Modification 11 to 06_0250 Seaside Boulevard, Fern Bay

Date: 12 November 2018

This is my response to Modification 11 described as follows:

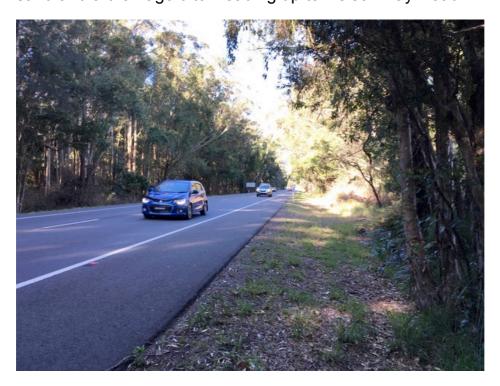
The "formed fire trail" as described above is simply not true, as the following photos will demonstrate.

There is a substantial drain between the edge of Nelson Bay Road and the locked gate that would present a serious obstacle for emergency vehicles and normal vehicles other than Four Wheel Drive vehicles.

From the locked gate to the Nelson Bay Road is a further 25m of completely unprepared bush vegetation, loose sand and drainage ditch that only four wheeled drive vehicles could negotiate.

I don't know how any emergency vehicles could use this bush track, even as a temporary access road.

The above photo shows the 3m locked gate and the 25m of bush, loose sand and a drainage ditch leading up to Nelson Bay Road.
